# **BRIHANMUMBAI MUNICIPAL CORPORATION**

Ch.E./D.P./ 18005-1 Gen

**Sub:** Revision / partial modification to policy circular C-10 in respect of elevation features to be permitted to proposed building<sup>(s)</sup> in Mumbai.

# SKETCH 2

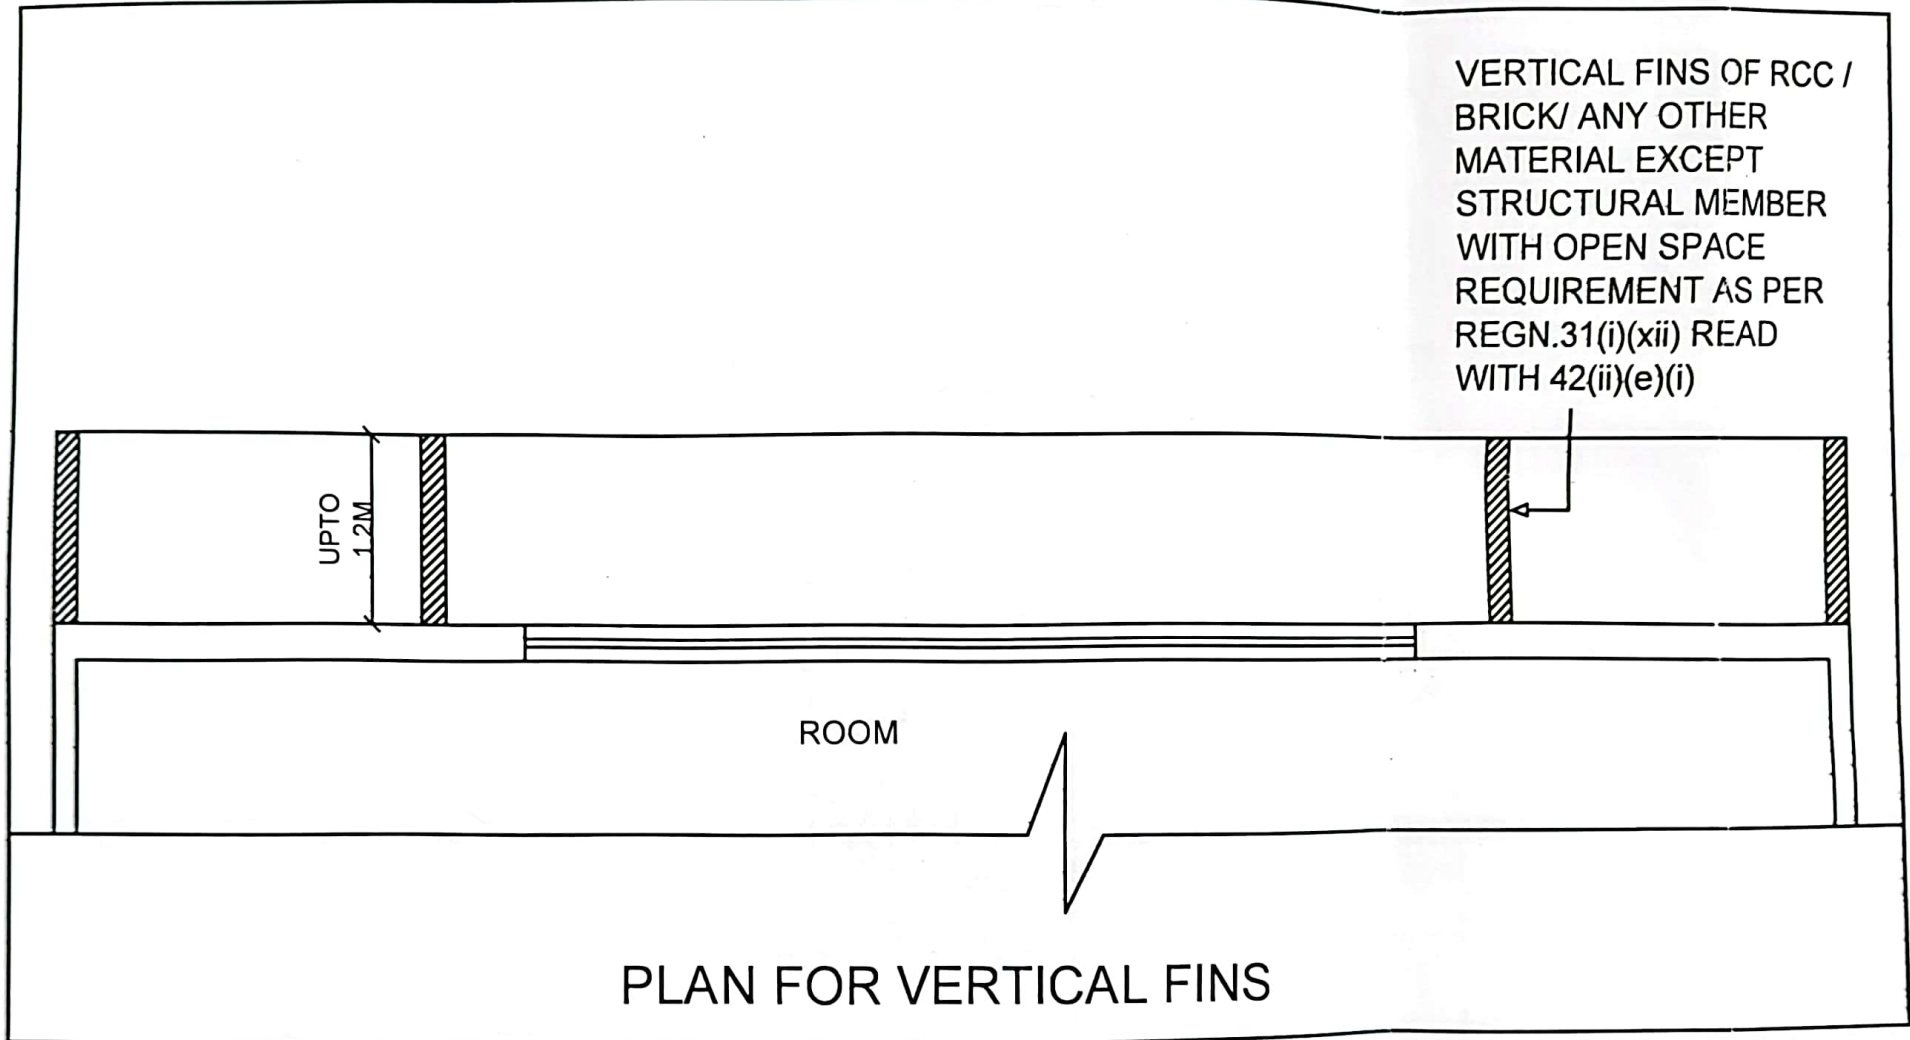
(2)	ELEVATION FEATURES:	Chajja, cornice, weather shade, sunshade fins projections allowed at lintel level to be projected to 1.2 meters.	1.2 mtr. wide horizontal and vertical chajja projection (any level) to be free of FSI of the buildings for –	<p>Reg. 31(1)(xii) and (xiii) of DCPR 2034 read as under,</p> <p><b>I) Reg. 31(1)(xii):-</b>  <i>"A chajja, cornice, weather shade, sun-breaker, at lintel level, only &amp; vertical fins (excluding column); projecting not more than 1.2 m. from the face of the building as provided in sub regulation no. 42 (ii)(e)(i)."</i></p> <p><b>II) Reg. 31(1)(xiii):-</b>  <i>"A chajja, cornice, weather shade, sun-breaker over a balcony or gallery, as provided in sub regulation no. 42(ii)(f)(i)."</i></p> <p>I) Chajja, cornice, weather shade, sun-breaker, at lintel level only may be permitted as shown in sketch No. 1 as per Regn. 31(1)(xii) read with Regn. 42(ii)(e)(i) of DCPR 2034.</p> <p>Also, in case of chajja / weather shed, if provided in sloping / slant / curved shapes which cannot be misused, same may be allowed with angle enough to maintain minimum 600 mm level difference as shown in sketch.</p> <p>The chajja will be allowed at lintel level only</p>

<p>with slanting, curved or any other shape features without any filling and it shall start from 300 mm below floor level. The slanting or Curved material shall be of light weight materials only to take self weight and shall be fixed as per design requirements.</p> <p>Further, chajja, cornice, weather shade, sun-breaker over a balcony or gallery as shown in Sketch No. 1 shall be allowed as per Reg. 31(1)(xiii) read with Reg. 42 (ii)(f)(i) of DCPR 2034.</p> <p>Further it is to clarify that the 600 mm level difference shall be as per sketches accompanying in circular C-10.</p>
		<p>A) Vertical fins of brick work or any other material except Structural member to be permitted.</p>	<p>II) Vertical fins of brick work or any other material except Structural member as shown in sketch No. 2 shall be allowed as per Reg. 31(1)(xii) read with Reg. 42 (ii)(e)(i) of DCPR 2034.</p>
		<p>B) Vertical box of 60 cm. on external face to be permitted.</p>	<p>PEATA (I) has shown 0.60 mtr. wide vertical box as shown in Annexure-II of representation. However, such vertical box may be allowed with RCC / Brick work and shall be kept hollow. RUT for not misusing the same shall be insisted.</p> <p>Such ornamental projection shall be permissible free of FSI as per regulation 31(1) and 42(ii)(e)(ii), maximum up to 1.2 m depth with Special Permission of Commissioner. (Sketch No. 3)</p>

# SKETCH 4

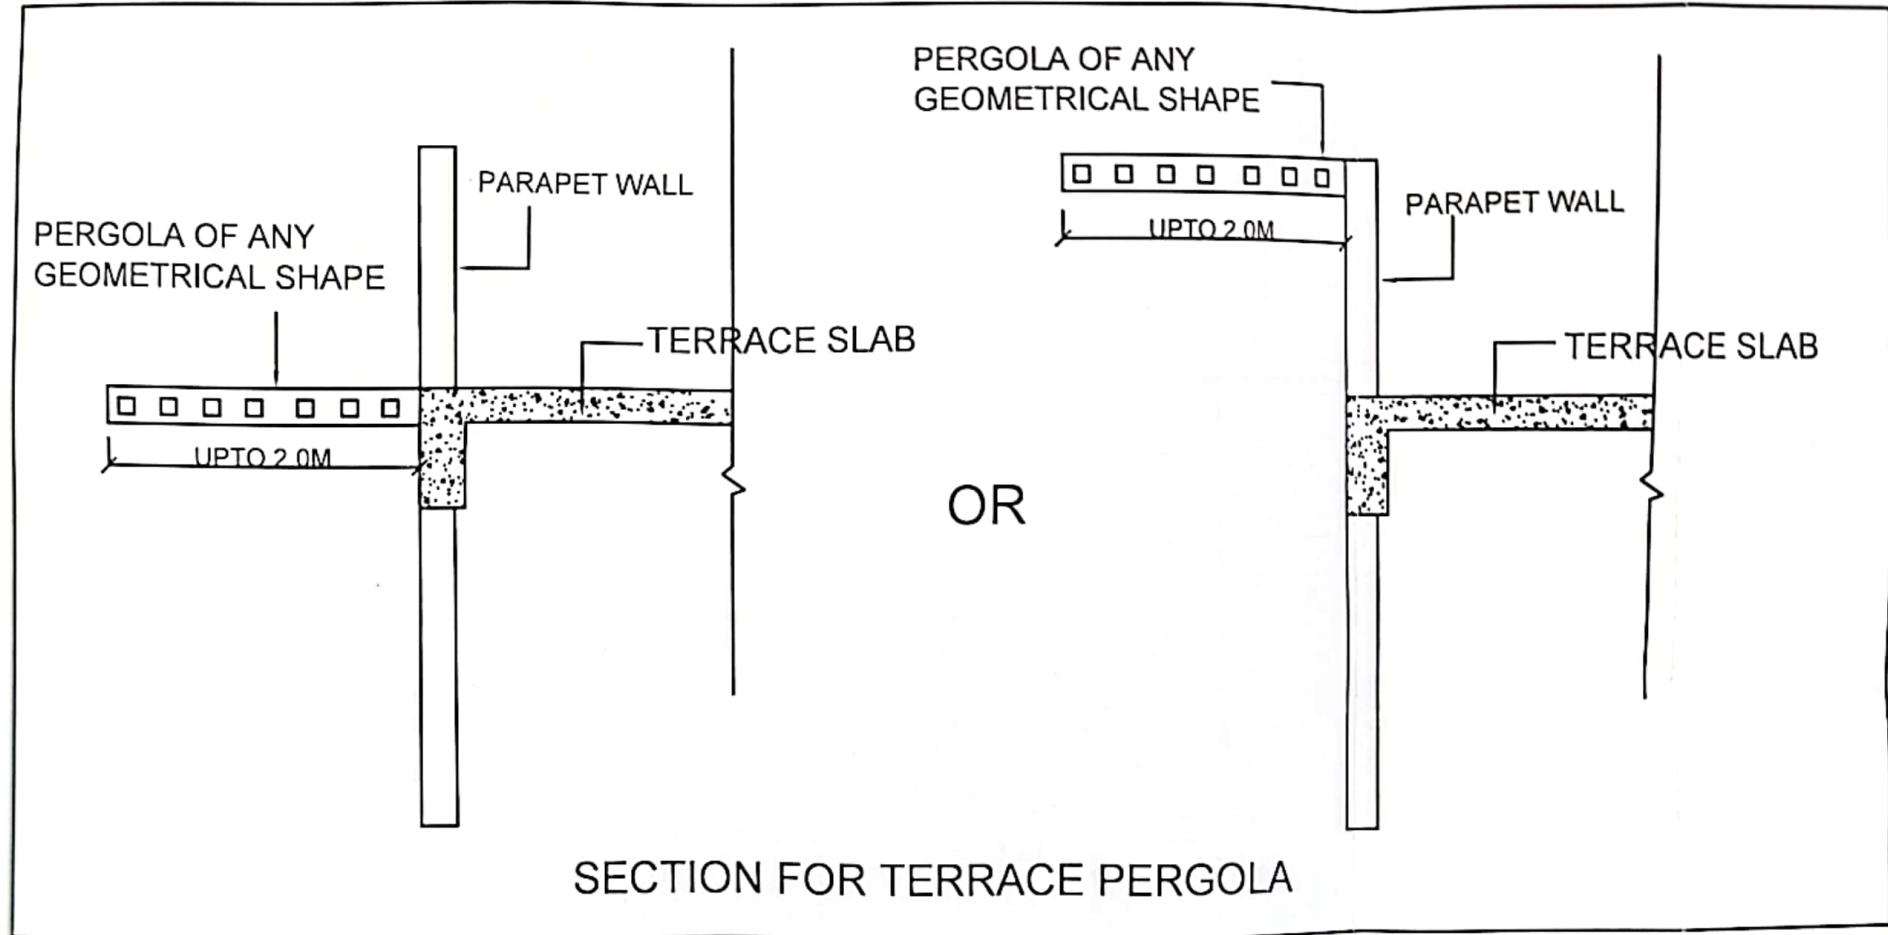
<p>C) Pergola to be permitted at topmost terrace level and at top of the parapet wall with maximum projections of 2.0 mts. with 1.20 mts.</p>	<p>As per Sr. No. 3 of Circular no. C-10 for allowing elevation features to building, pergola at terrace slab level projecting beyond the building line up to 2.0 m is allowed free of FSI.</p> <p>PEATA (I) has represented that in addition to terrace slab level, the same shall also be</p>

<p>projection on the common terrace.</p> <p><b>(Annexure II)</b></p>	<p>allowed on the top parapet wall above topmost terrace.</p> <p>The same may be considered if the pergola is constructed either at terrace level or at top of parapet level with Special permission of Commissioner. (Sketch No. 4)</p>
		<p>D) Free standing column &amp; cornices will also be permitted within the projection upto maximum 1.20 mts.</p>	<p>PEATA(I) has represented to allow free standing columns, purely for architectural feature of buildings as shown in attached sketch.</p> <p>Same may be permitted from 1<sup>st</sup> floor onwards as ornamental Projection permissible under Reg. 31(1) and 42(ii)(e)(ii) maximum up to 1.2m, with Special Permission of Commissioner, provided that such columns shall not be structural members of building &amp; shall not reduce the Open Space as specified in Regn. 42(ii)(e)(ii) &amp; Reg. 47(1) of DCPR 2034, without affecting light and ventilation of any part of the building. (Sketch No. 5)</p>

SKETCH 7

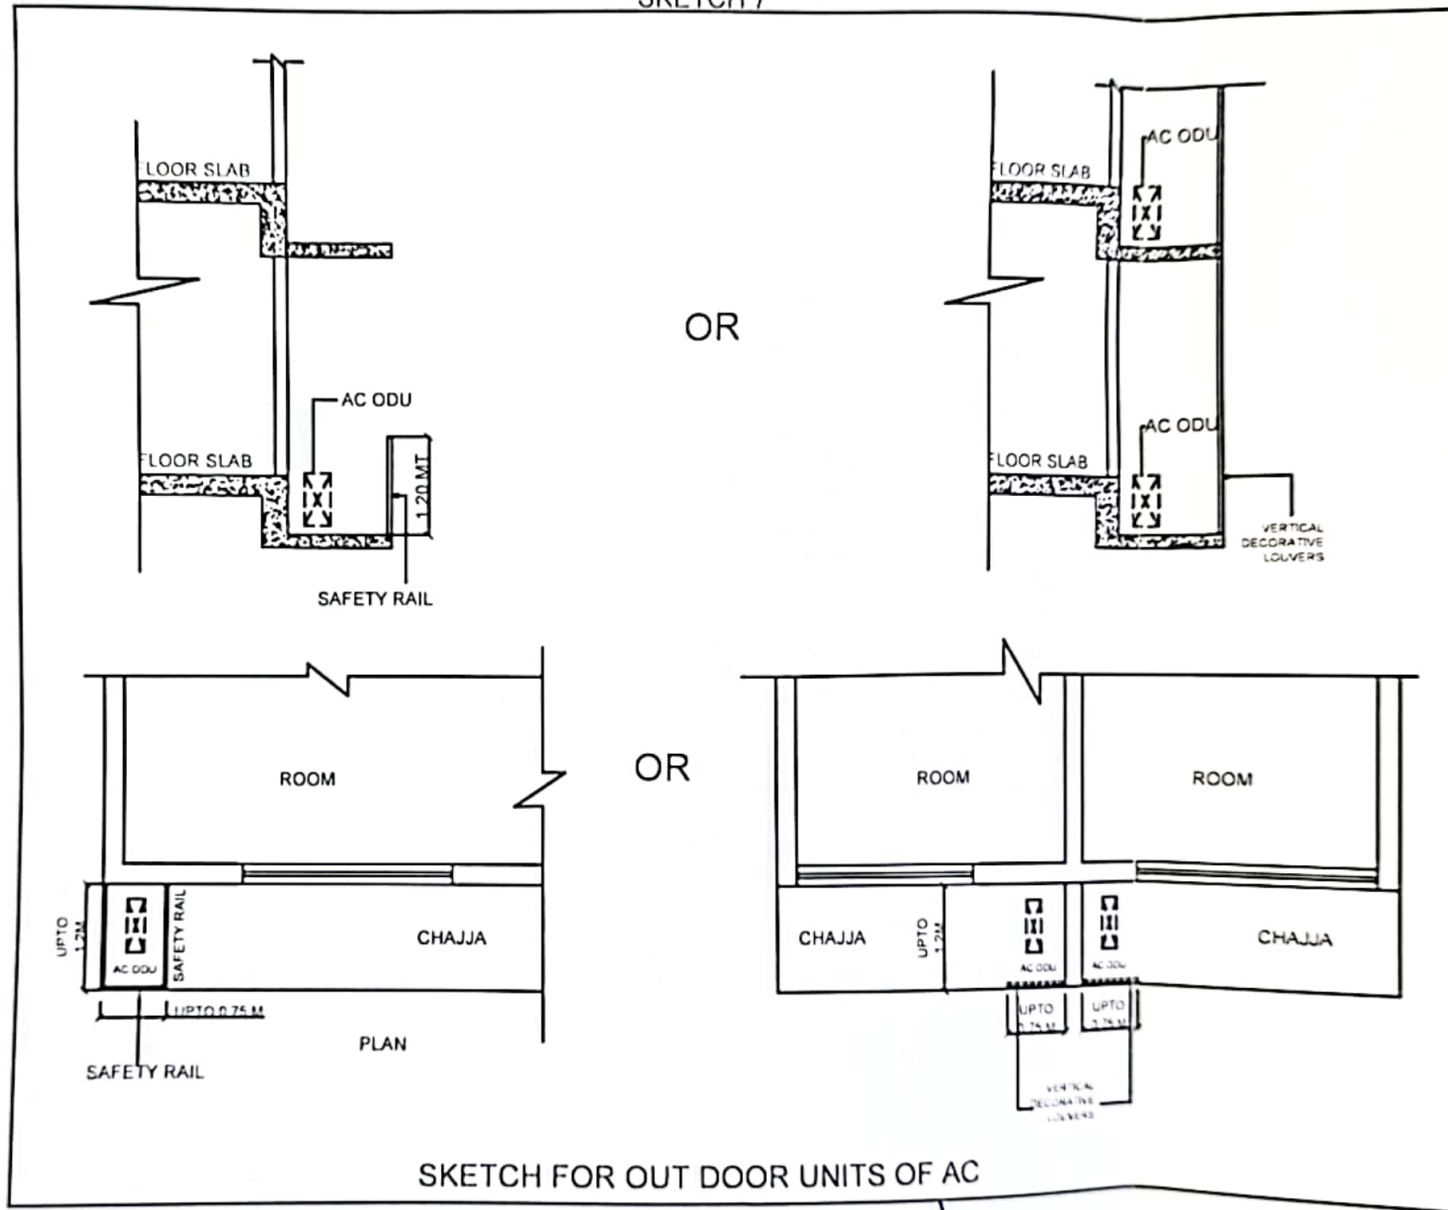
protection of compressor machines. (Annexure III)	then may be allowed with prior permission of Commissioner. PEATA(I) vide above representation has requested that A.C. unit be allowed on RCC platform (like chajja) <del>with</del> <sup>with</sup> 1.2 m x 2.0 mt. size with safety railing and / or vertical louvers for aesthetical reasons, even at any other suitable location than service ducts, along dead portion of wall without affecting L/V. However, same shall not cover/reduce window opening proposed for light & ventilation. The request is to allow RCC platform with safety railing and vertical louvers for aesthetical reasons only but at such location that will not affect L/V of any of the part of building. This ODU unit on RCC chajja / platform may be allowed as shown in sketch No. 7, however it shall not reduce the Open Space as specified in Reg. 42(ii)(e)(i) & Reg. 47(1) of DCPR 2034 (Sketch No. 7)
